Staff recommends the HPC **approve** the HAWP.

SIGNIFICANCE: Contributing Resource within the Greenwich Forest Historic District  
 STYLE: Colonial Revival  
 DATE: 1933

# APPLICATION FOR HISTORIC AREA WORK PERMIT

HISTORIC SUBMISSION  
3/2/22

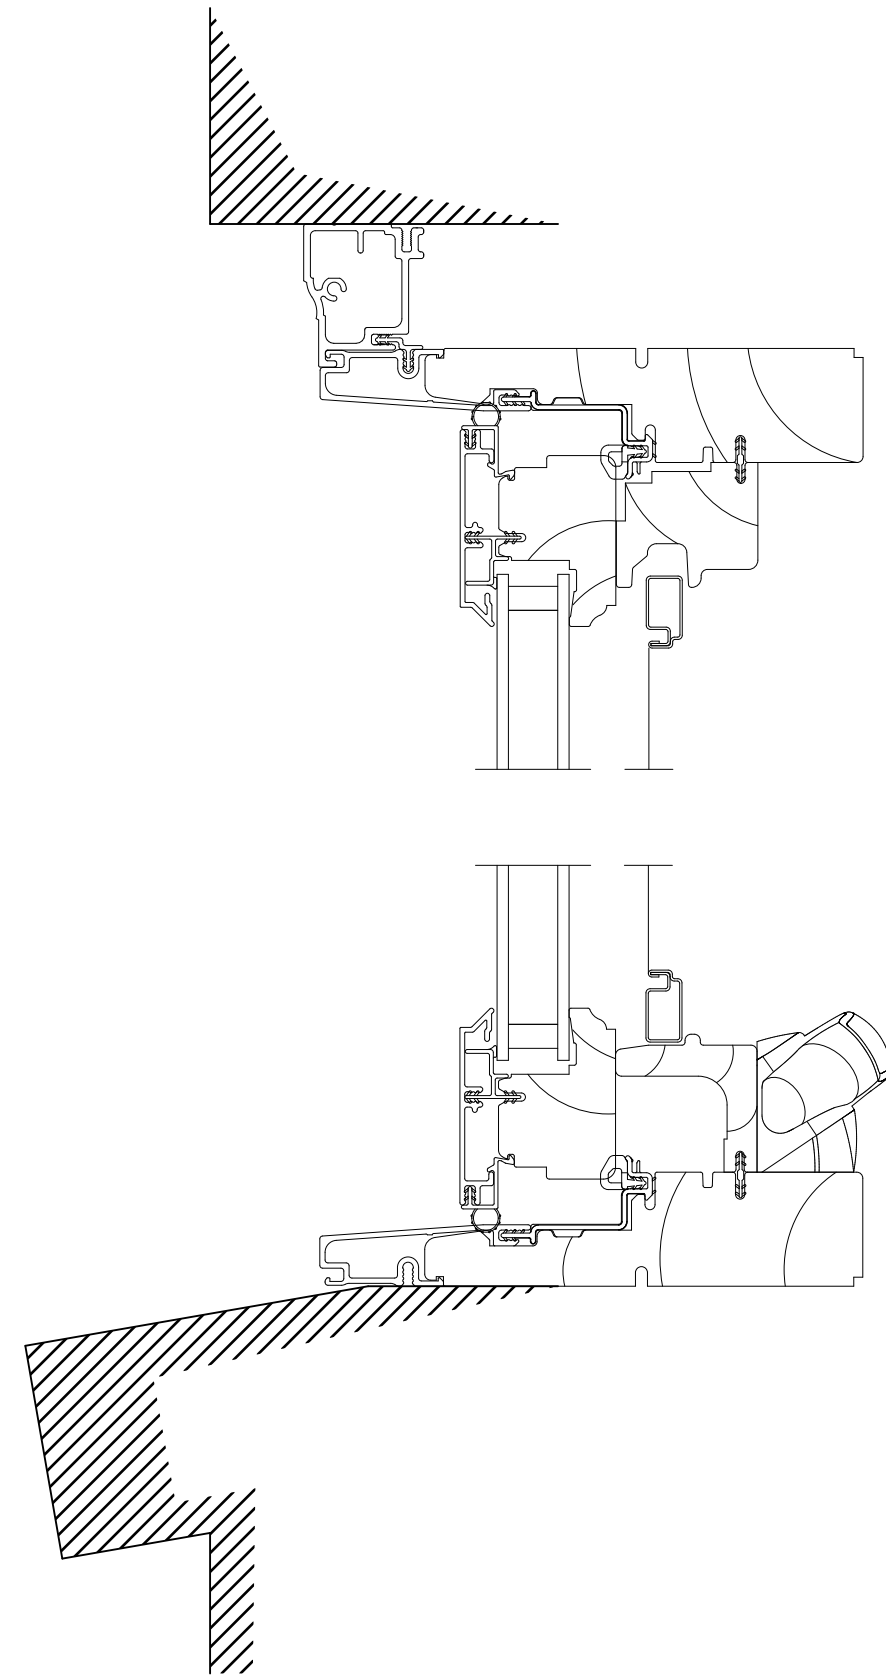
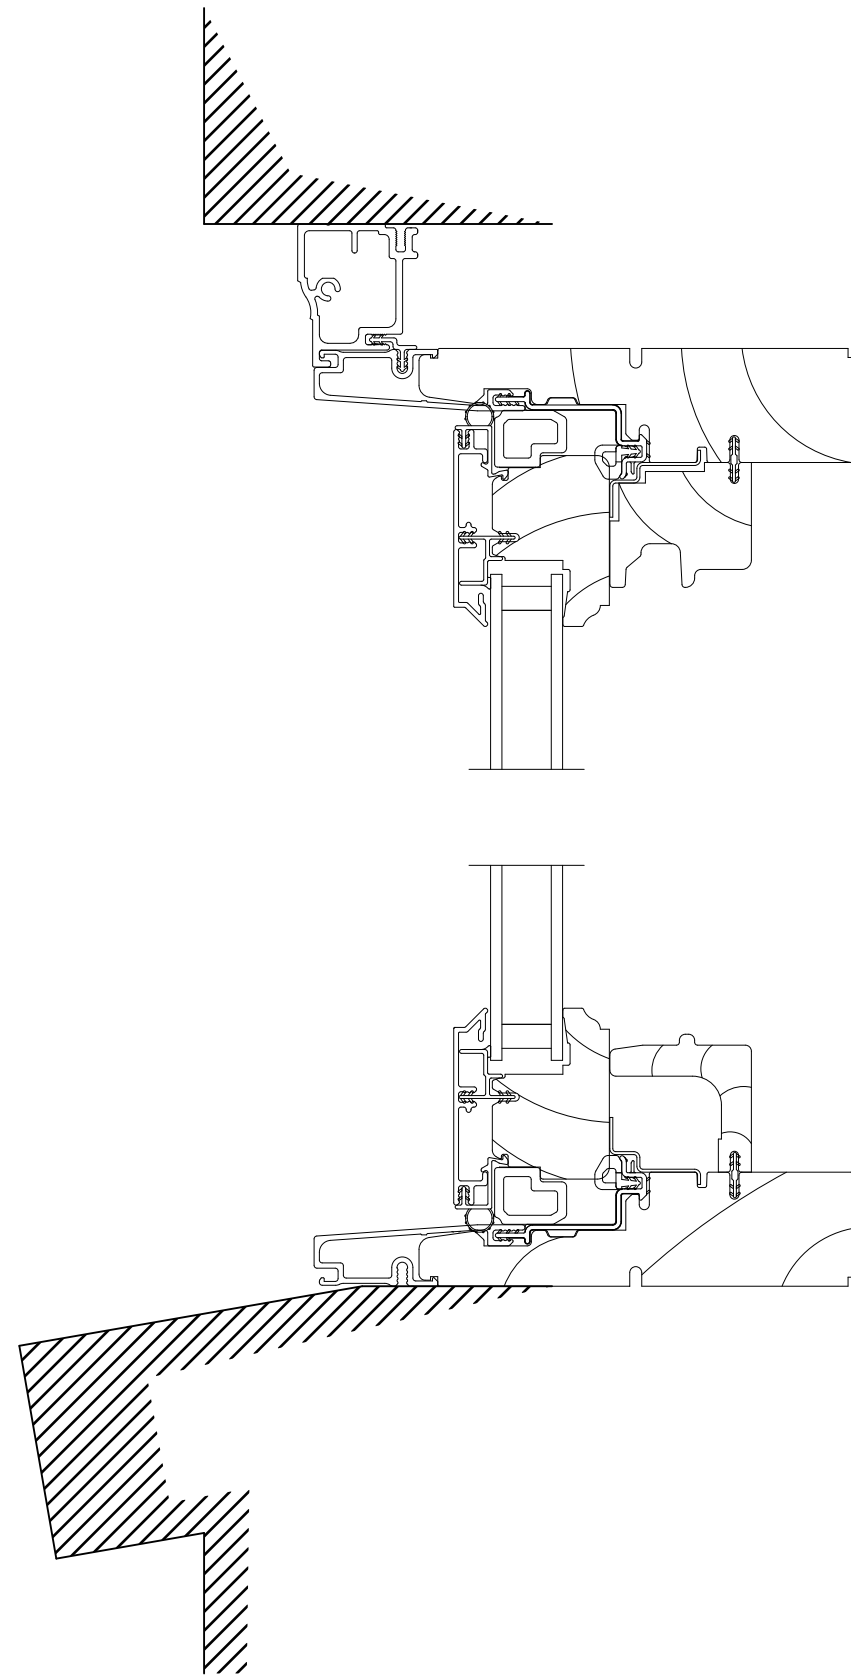
On the northwest (right side) elevation, the applicant proposes to install two sets of clad casement windows on the first floor and to brick in a narrow window opening. On the southwest (rear) elevation, the applicant proposes to enlarge two window openings and install new fixed aluminum clad twelve-lite windows. The applicant proposes to install two pairs aluminum clad French doors, one on the southeast elevation, the other on the southwest elevation. The application materials also indicate that the bay window off of the rear terrace will have a reclaimed steel window installed in the existing bay. Lastly, the applicant proposes to replace a non-historic door with a wood door and wood screen door.

Unlike other districts in the county, the Greenwich Forest Historic District does not require an applicant to demonstrate that windows and doors have deteriorated beyond repair. The only requirements (D17) are that the replacement windows and doors need to be compatible with the architectural style of the house. Staff finds the multi-lite, aluminum clad windows are compatible with the Tudor elements of the subject property and its multi-lite casement windows. Staff additionally finds steel casement windows are appropriate in the bay at the rear. Staff recommends the HPC approve the window and door replacements.
